**NRC STAFF RESPONSE TO PUBLIC COMMENTS ON
NUREG/CR-7002, REVISION 1, “CRITERIA FOR DEVELOPMENT OF
EVACUATION TIME ESTIMATE STUDIES”
85 FR 52930 (August 27, 2020)**

On August 27, 2020, the U.S. Nuclear Regulatory Commission (NRC) issued for public comment in Volume 85 of the *Federal Register* (FR), page 52930 (85 FR 52930), draft NUREG/CR-7002, “Criteria for Development of Evacuation Time Estimate Studies,” Revision 1 (Agencywide Documents Access and Management System (ADAMS) Accession No. ML20233A700). The FR notice provided a 45-day public comment period, which expired on October 13, 2020. Comments on the subject NUREG are available electronically in the NRC’s electronic Reading Room at <https://www.nrc.gov/reading-rm/adams.html>. From this page, the public can enter ADAMS, which provides text and image files of the NRC’s public documents.

Figure 7-5. Congestion Patterns at 4 Hours after the Advisory to Evacuate

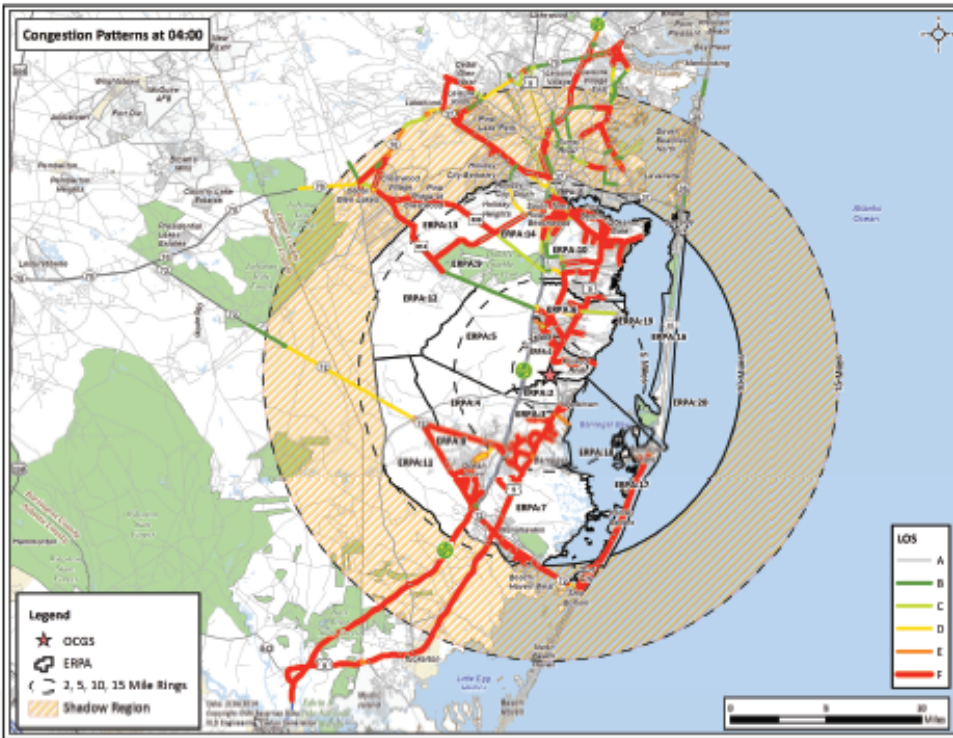
Staged Evacuation—Section 1.4.1—Pages 1-9, 1-10

Lines 11 through 14 read “If the site-specific PAR logic addresses staged evacuation, then the licensee should include in the ETE study a discussion on the approach used in the development of staged evacuation scenarios. Licensees should include a staged evacuation analysis for initial PAR strategy development as described in Section 5.6.” This is the proverbial “putting the cart before the horse.” The ETE study is supposed to inform the PAR. If the ETE study deems staged evacuation to be beneficial to those people living in the 2-mile region, then the licensee and OROs should include staged evacuation in their PAR logic if they feel it can realistically be implemented. By saying staged evacuation analysis should be done if it is in the existing PAR logic, you are relying on PAR logic that was developed after the last full ETE study. What if the population in the 2-5 mile area has drastically changed in the last decade (this is happening in Florida and the Carolinas) and staged evacuation is now beneficial based on population distribution when it was not beneficial a decade earlier? The original version of NUREG/CR-7002 (dated November 2011) required a staged evacuation analysis for all sites. Nearly all sites showed no benefit from staged evacuation (after a rigorous quantitative analysis) after the 2010 Census. We recommend the following approach for determining whether staged evacuation analysis should be further considered for a site in the new guidance document. Run an ETE simulation for an evacuation of the full EPZ for the scenario (non-special event) that has the highest number of evacuating vehicles. If the simulation indicates traffic congestion (Level of Service F) and queuing that extends from outside the 2-mile region into the 2-mile region, it clearly shows that evacuation beyond the 2-mile region is delaying the egress of people within the 2-mile region. If that occurs, then a quantitative analysis of staged evacuation (comparing ETE with and without staged evacuation) should be done. This is the fundamental idea of staged evacuation...get the people in the 2-mile region out as quickly as possible. It should only be considered for sites where it is a valid concern. As an example, Oyster Creek Generating Station is one of the few sites that exhibited an ETE benefit of staged evacuation after the 2010 Census. Attached is Figure 7-5 from the Oyster Creek ETE report which shows traffic congestion on US Highway 9 northbound that extends from the EPZ boundary into the 2-mile radius just north of the plant at 4 hours after the advisory to evacuate. Clearly, in this example, evacuation of the 2-mile radius is hindered by evacuation of those beyond 2 miles and further analysis of staged evacuation is needed.

The NRC agrees with the comment. The evacuation time estimate (ETE) should inform the protective action recommendation (PAR) strategy. And the draft guidance could be interpreted not to consider staged evacuation which is not the intent. The guidance in NUREG/CR-7002 needs to support that in NUREG-0654, Supplement 3, "Criteria for Preparation and Evaluation of Radiological Emergency Response Plans and Preparedness in Support of Nuclear Power Plants: Guidance for Protective Action Strategies," (ADAMS Accession No. ML113010596) for the development of PAR strategies. Staged and keyhole evacuation ETEs should be evaluated as per the original issue of NUREG/CR-7002. The staff removed the conflicting statement on lines 11 through 14 in Section 1.4.1. The staff also revised Section 1.4 to reflect the original guidance and development of keyhole and staged evacuation ETEs, but also to reflect variable sized emergency planning zones. Changes were made to Section 4.7 to conform with the revised bulleted list of Section 1.4. Finally, the staff added headers for Section 1.4.1 on keyhole evacuations and Section 1.4.2 on staged evacuations to clearly distinguish those parts of the guidance.

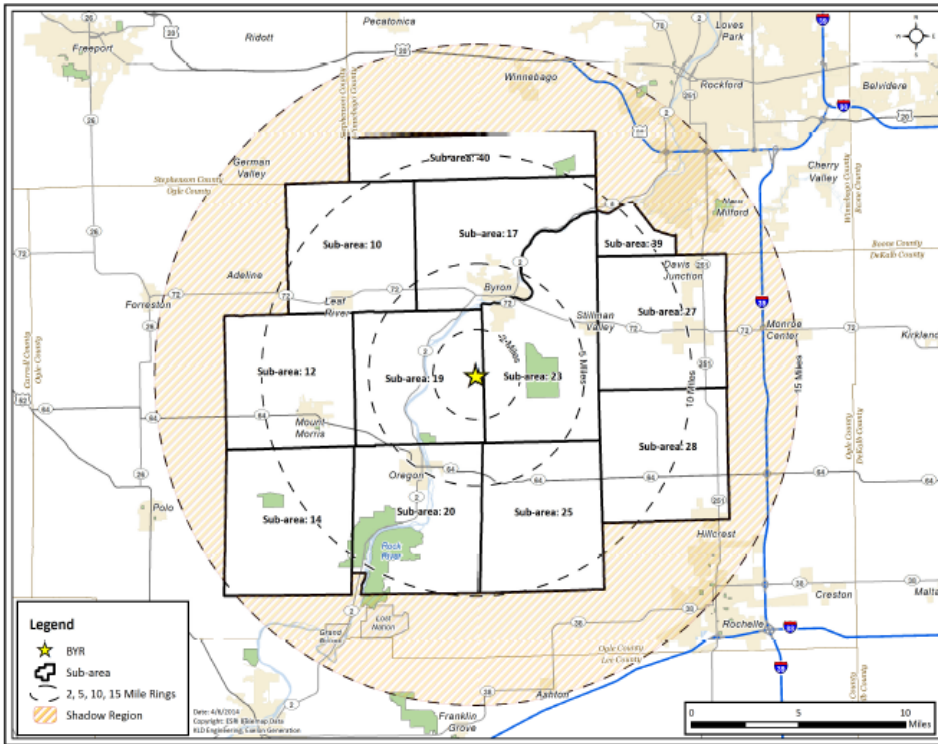
Lines 40 through 42 read "... in some cases, the shadow region may need to be extended to include the influence of major population centers as shown in this figure." Please provide more specific guidance. What defines a "major population center"? Population exceeding 20,000 people, 50,000 people, etc.? Also, Figure 2-2 shows the major population center intersecting the

EPZ Shadow Region. Should the Shadow Region be extended to include the major population center only when it intersects the recommended Shadow Region ("at least half the radial distance of the evacuation area"), or should it also be considered if the major population center is near the recommended Shadow Region? Also, how much of the major population center needs to be considered? If the population center intersects the recommended Shadow Region and extends an additional 5-miles beyond the Shadow Region, does the whole population center need to be considered? We understand that it is an engineering judgment call as to whether a nearby population center should be considered and how much of it should be considered. We would just like a bit more guidance on this subject to ensure the guidance is interpreted commonly by all who may use it.

The NRC agrees with the comment. The guidance is based on 1-mile buffers throughout. Capacity reductions and populations centers, if included, should extend the model, locally, about 1 additional mile along major evacuation routes of interest. Task 2 and Task 4 of the ETE Study (NUREG/CR-7269) indicate there is a very high threshold for when population centers outside the emergency planning zone (EPZ) would impact the ETE. This threshold is reached for population centers with populations approximately 4 times greater than the number of EPZ evacuees, based on the ETE study. The staff revised Section 2.5.2 to define the 50,000 evacuees more clearly as based on the permanent resident and transient populations within the EPZ. The staff also added a discussion on the insensitivity of the shadow analysis for EPZs with less than 50,000 evacuees. Finally, the staff revised the guidance to reference Section 4.5 to state when the model boundaries may need to be extended an additional mile due to capacity reductions or the presence of population centers.

Farley Shadow Region

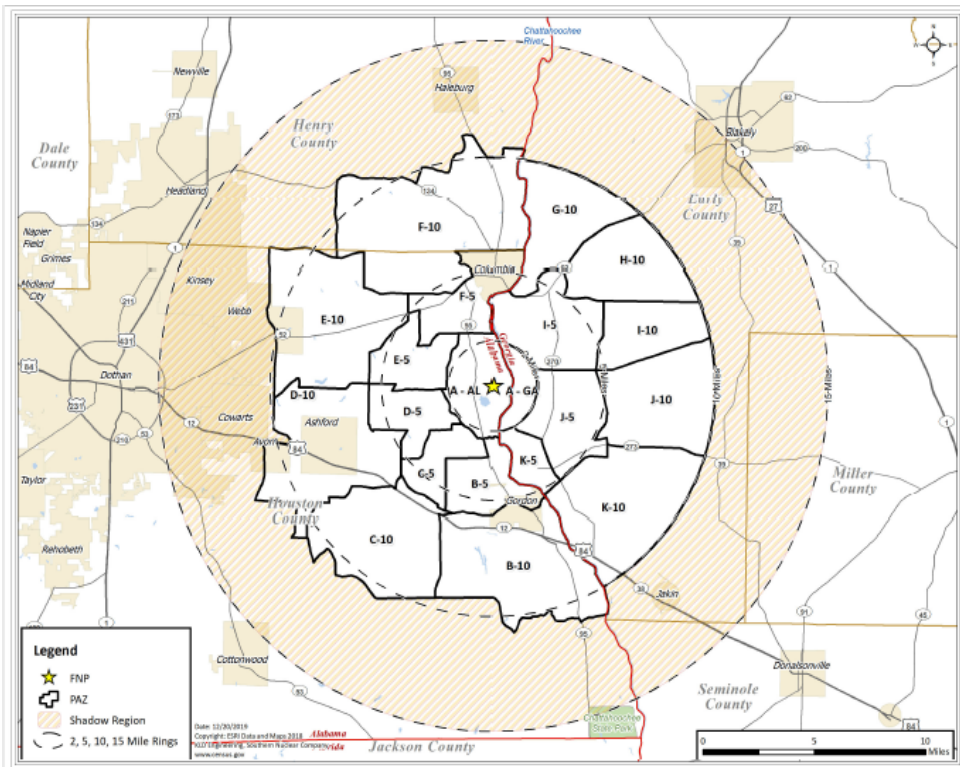
Lines 40 through 42 on page 2-5 "... in some cases, the shadow region may need to be extended to include the influence of major population centers as shown in this figure" and lines 5 through 7 on page 2-7 "ETE studies do not need to model a shadow evacuation if the number of evacuees is less than 50,000 and 20 percent of the shadow population is less than half of the evacuating population" could conflict with one another for some sites. We offer two examples: (1) Byron Generating Station – the EPZ population as per the 2010 Census was 29,116 people (less than 50,000). The population in the Shadow Region (from EPZ boundary to 15 miles) was 34,644, 20% of which is 6,929 people, which is less than half of the evacuating population in the EPZ. Based on the page 2-7 criteria, a Shadow Region does not have to be considered for this site. However, as shown in the attached figure, the City of Rockford, IL intersects the 15-mile radius. The population of Rockford was approximately 152,000 people per the 2010 Census. A city that densely populated could impact ETE for the Byron Generating Station and should likely be considered as part of a shadow evacuation for the site. (2) Plant Farley - the EPZ population as per the 2010 Census was 10,707 people (less than 50,000). The population in the Shadow Region (from EPZ boundary to 15 miles) was 20,402, 20% of which is 4,080 people, which is less than half of the evacuating population in the EPZ. Based on the page 2-7 criteria, a Shadow Region does not have to be considered for this site. However, as shown in the attached figure, the City of Dothan, AL intersects the 15-mile radius. The population of Dothan was approximately 65,500 people per the 2010 census. A city that densely populated could impact ETE for Plant Farley and should likely be considered as part of a shadow evacuation for the site.

The NRC partially agrees with the comment. Tasks 1, 2, and 4 of the ETE Study (NUREG/CR-7269) and a review of 2010 ETEs would not suggest that Rockford and Dothan would impact the ETE. However, Task 2 of the ETE study highlighted issues of route choice and Task 4 has examined the impact of background traffic. Both analyses would indicate there is a very high threshold for when population centers outside the EPZ would impact the ETE. This threshold is reached for population centers with populations approximately 4 times greater than the number of EPZ evacuees (for EPZs with more than 50,000 evacuees), based on the ETE study. This compares well with the information provided in this comment that suggests that cities with populations 5 to 6 times greater than the EPZ resident population may influence the ETE. However, the results of the ETE study indicate that for EPZs with less than 50,000 evacuees, the ETE is relatively insensitive to regions outside the study area. The staff revised Section 2.5.2 to define the referenced 50,000 evacuees more clearly as based on the permanent resident and transient populations within the EPZ and added a discussion on the insensitivity of the shadow analysis for EPZs with less than 50,000 evacuees. The staff also added guidance in Section 2.5.2 referencing Section 4.5 to address establishing boundary conditions for larger population sites (EPZs with more than 50,000 evacuees). Finally, the staff added clarification in Section 4.5 that boundary conditions are more important along major evacuation routes and for large population sites.
